FSI**FIELD
SERVICE
INFORMATION**

Product DS90 Floppy/Databoard interface board
Artikel

Bulletin no.	45
Bulletin nr	
Page no.	1/1
Sida nr

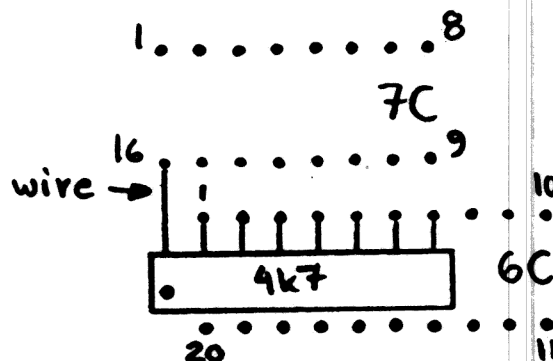
Problem: Poor noise immunity when floating point option is installed.

Action: Apply seven (7) 4.7K pullup resistors on the solder side of the board as follows:

Place a 7*4.7K SIL resistor network between the two rows of pins in position 6C (PAL16L8A PAT8022) and connect pins 2-8 of the SIL net to pins 1-7 on the IC.

Pin 1 on the SIL net should be connected to pin 16 (+5V) on the IC in position 7C.

Please refer to drawing below as seen from the solder side.
